### **AMENDMENTS TO THE DRAWINGS**

Attached hereto is(are) four (4) sheet(s) of corrected formal drawings that comply with the provisions of 37 C.F.R. § 1.84. The corrected formal drawings incorporate the following drawing changes:

Fig. 1

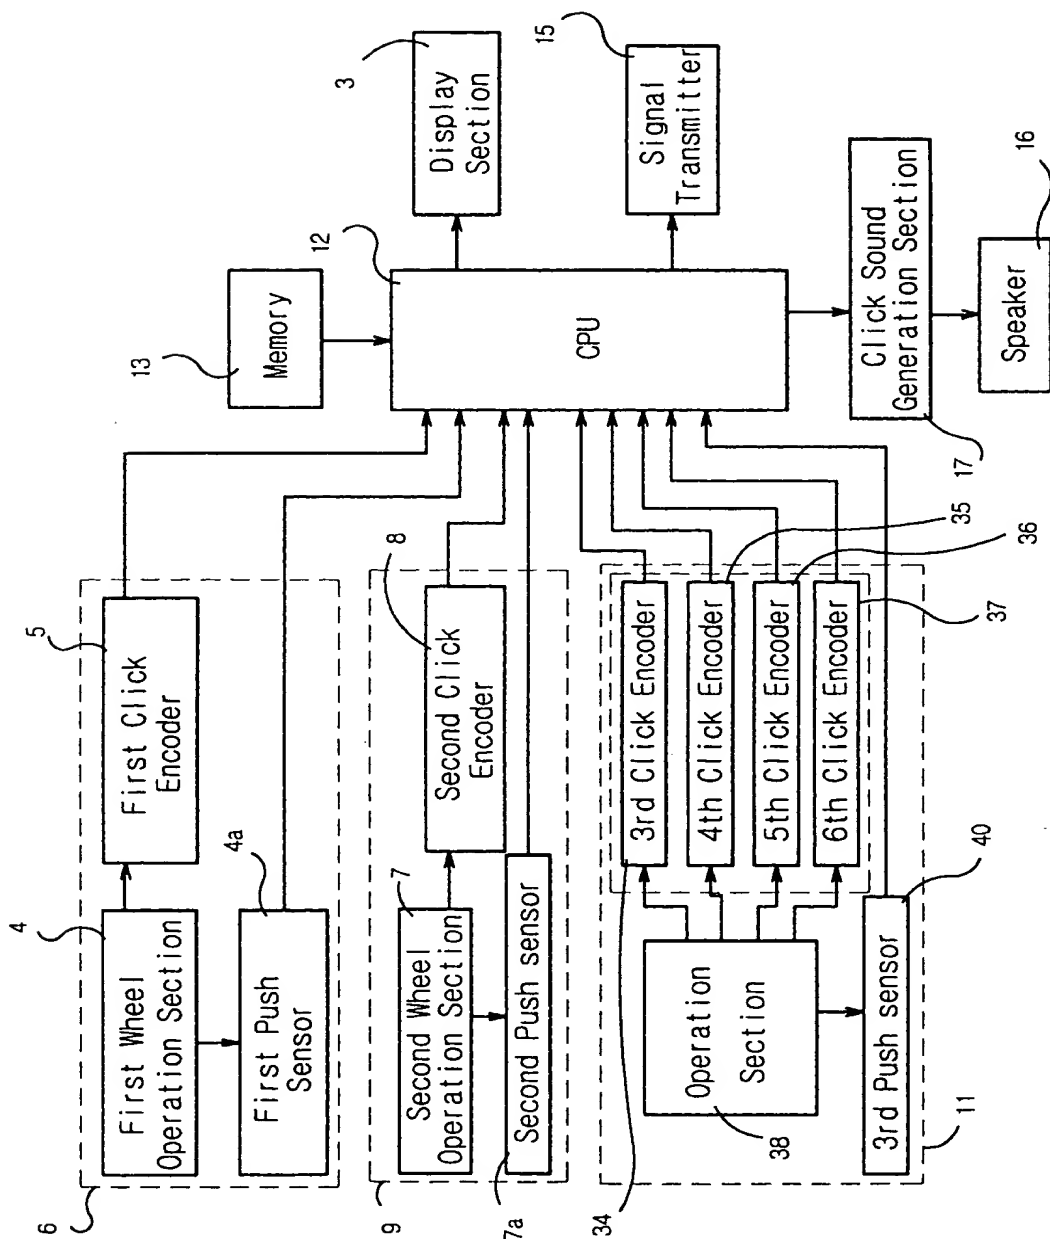
Figures 1, 6, 7, and 8 are amended as follows. In Figure 1, the boxes represented by reference numerals 4, 4a, 5, 7, 8, 34-37 and 40 are amended to read as follows: first wheel operation section; first push sensor, first click encoder, second wheel operation section, second push sensor, second click encoder, third click encoder, fourth click encoder, fifth click encoder, sixth click encoder, and third push sensor.

Fig. 6

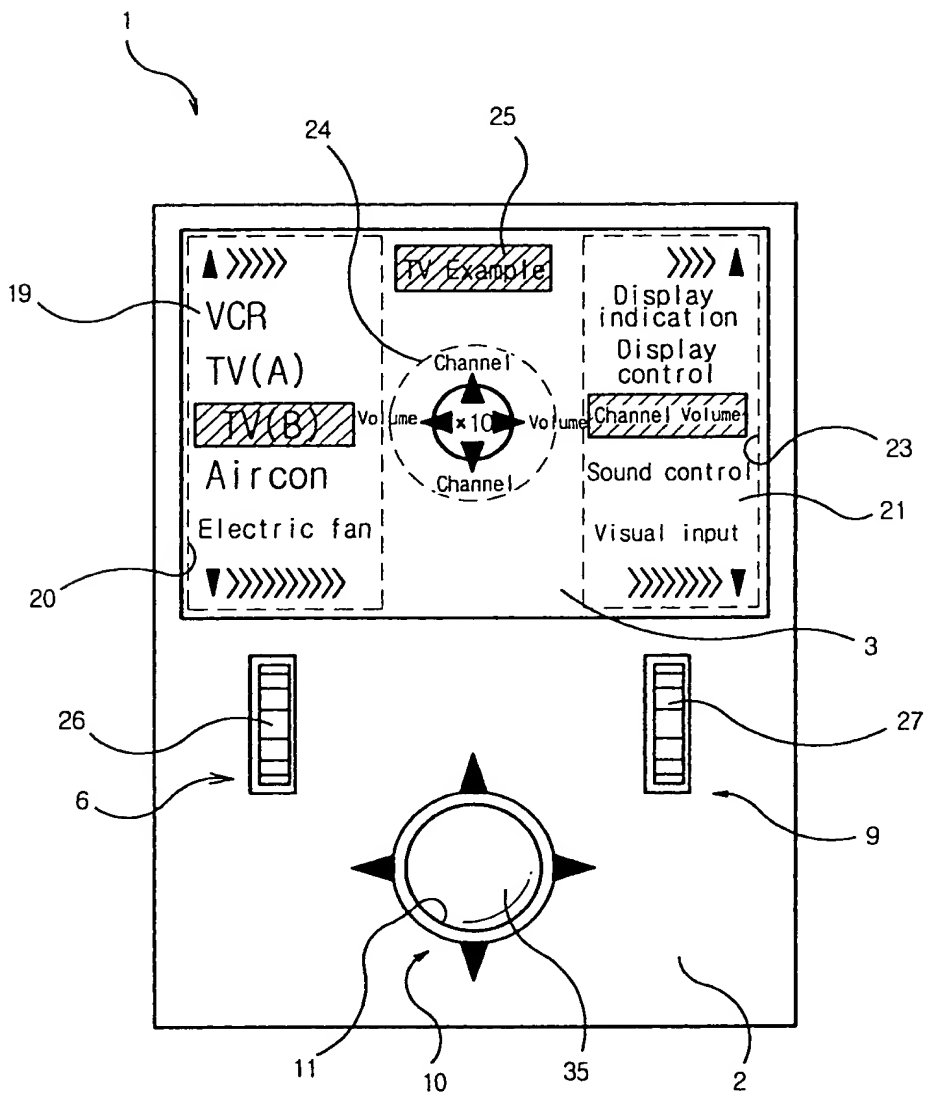
In Figures 6 and 7, the icon spelled "Chanel Volume" is replaced by "Channel Volume."
